Re: Arborist response to City of Roseville comment 56 for the:
Roseville Perio Dental Clinic
1623 Santa Clara Drive
Roseville, CA

Re: Arborist response to City of Roseville comments for the:
Roseville Perio Dental Clinic
1623 Santa Clara Drive
Roseville, CA

SHEET TITLE
ARBORIST SITE PLAN

SHEET NUMBER:
AB-01

ARBORIST SITE PLAN
3/32" = 1'-0"

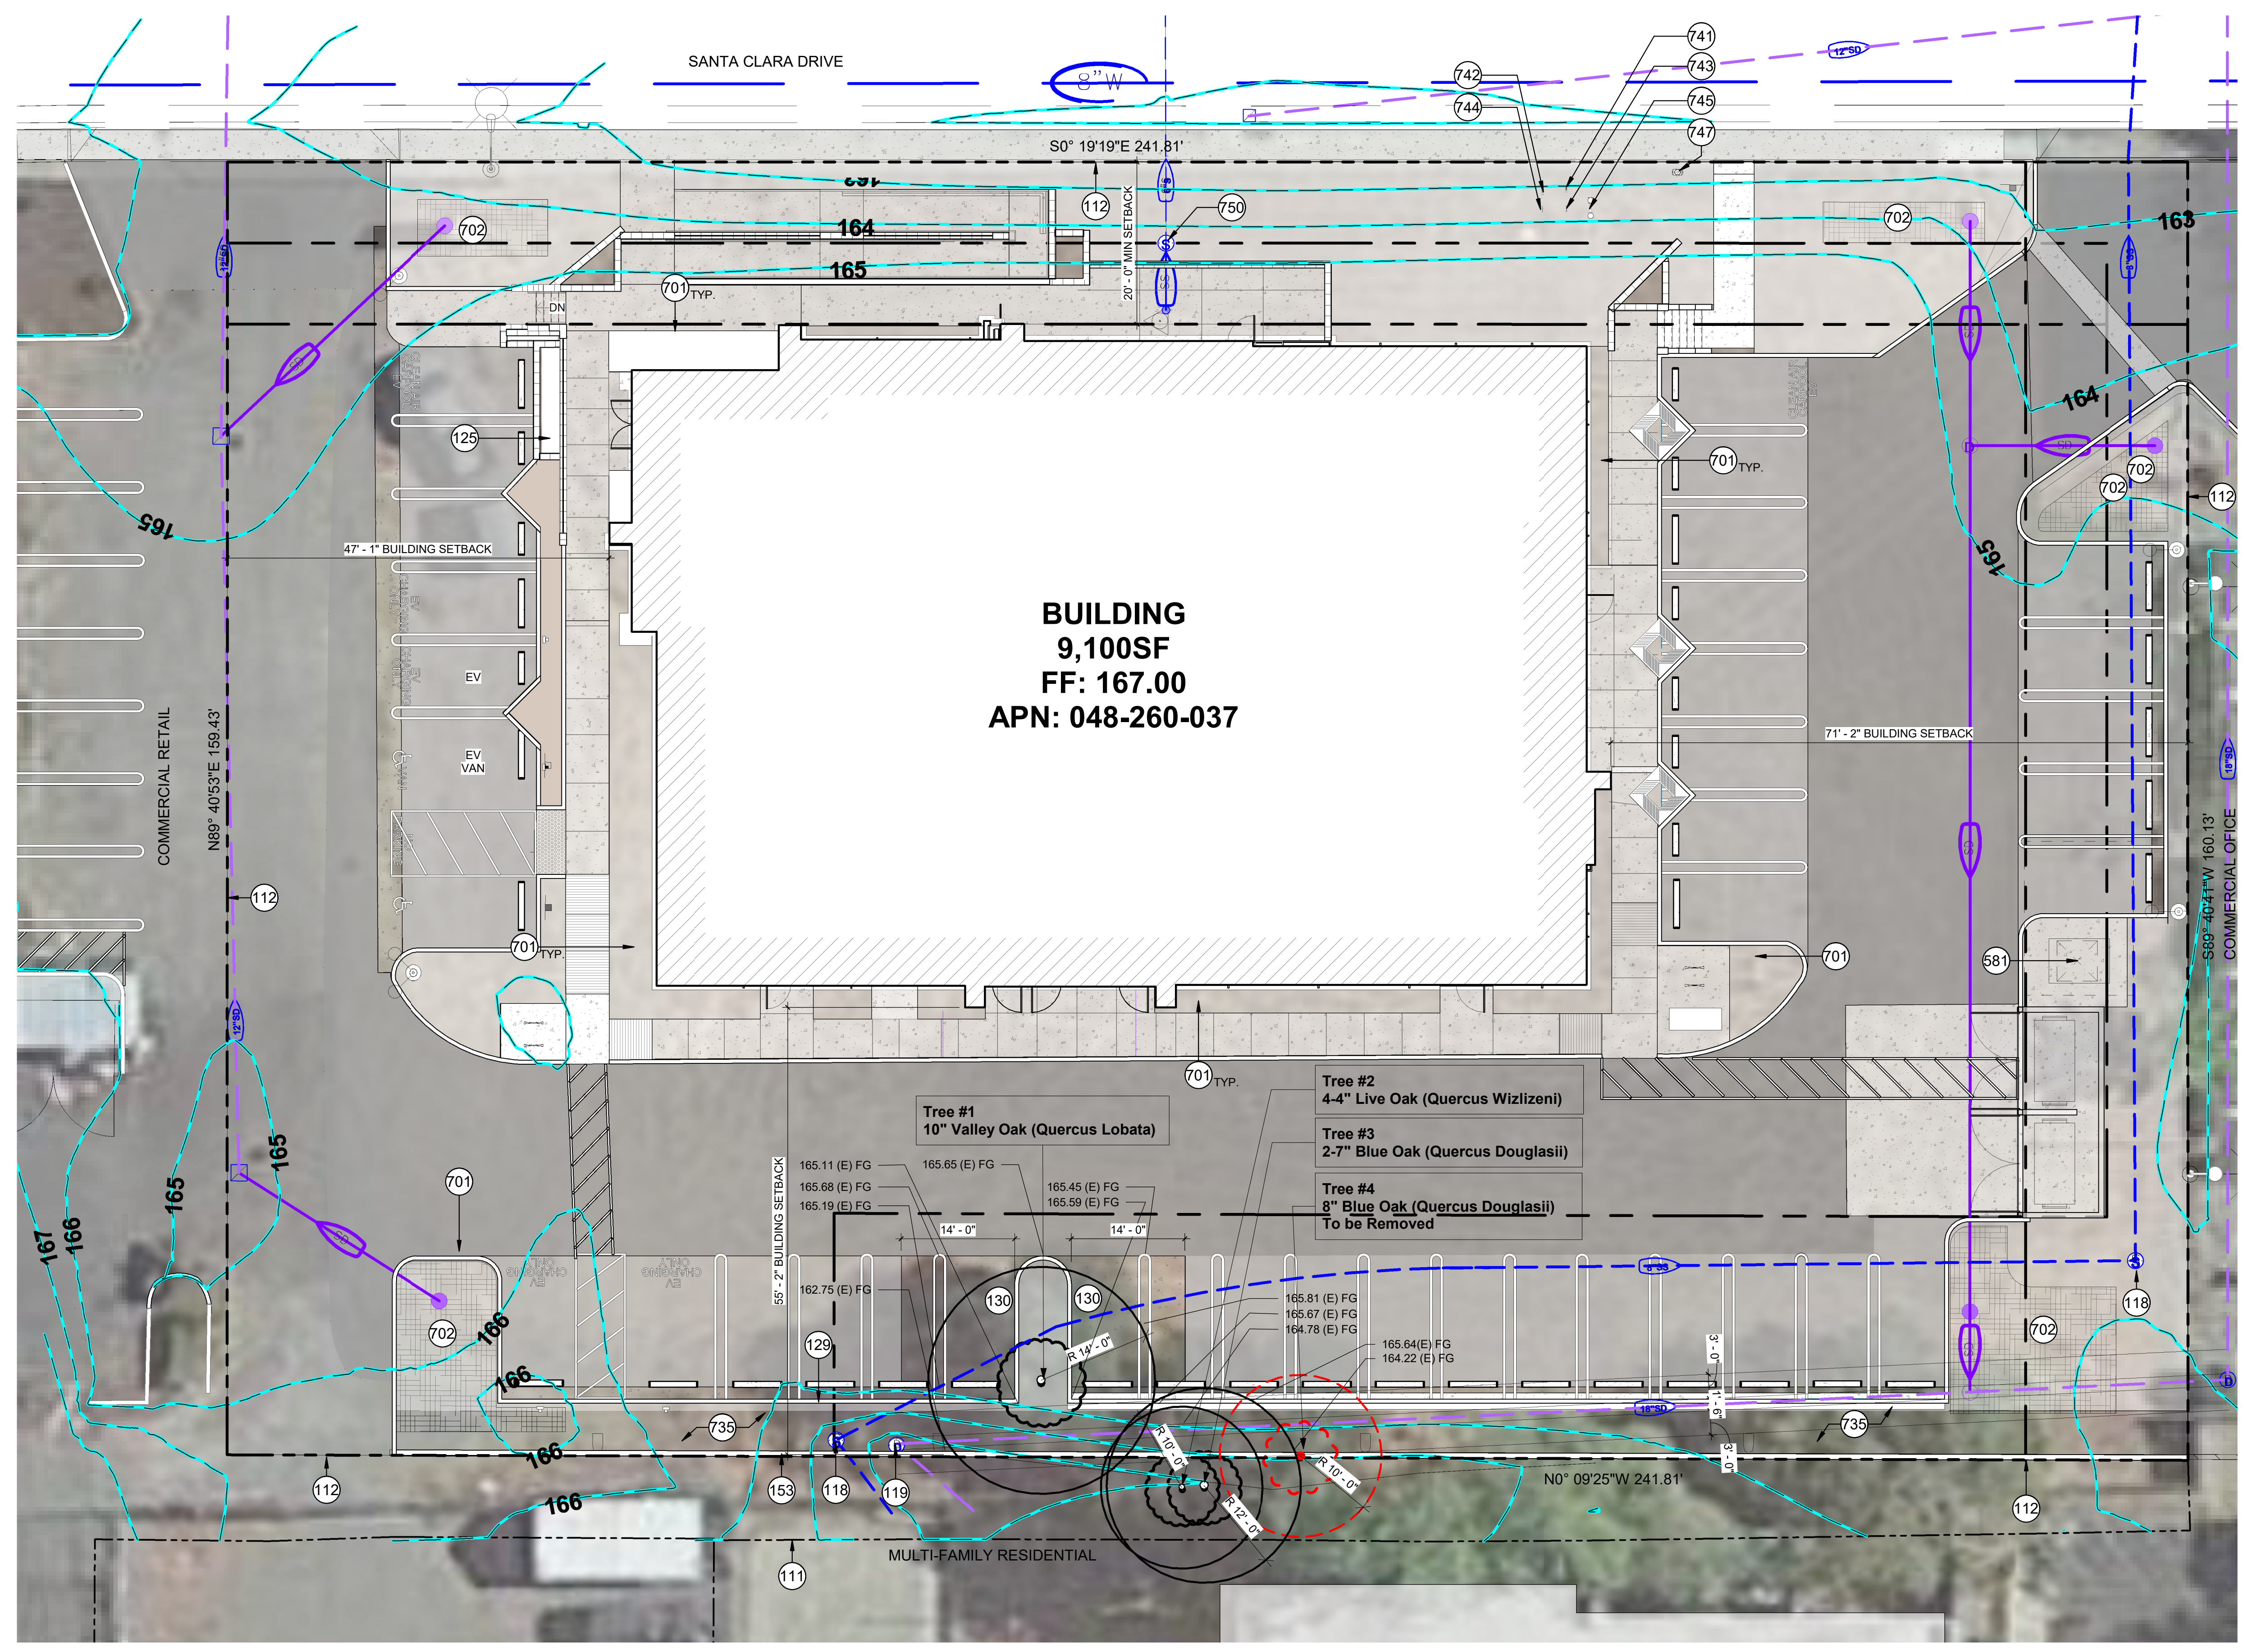
Comment 47:

Root zone encroachment approximately 40% mostly mitigated by pervious concrete placed on top of uncompacted original grade

Root zone encroachment of approximately 20%

Root zone encroachment of approximately 25%

Recommendation: Remove tree. It is on the property line.
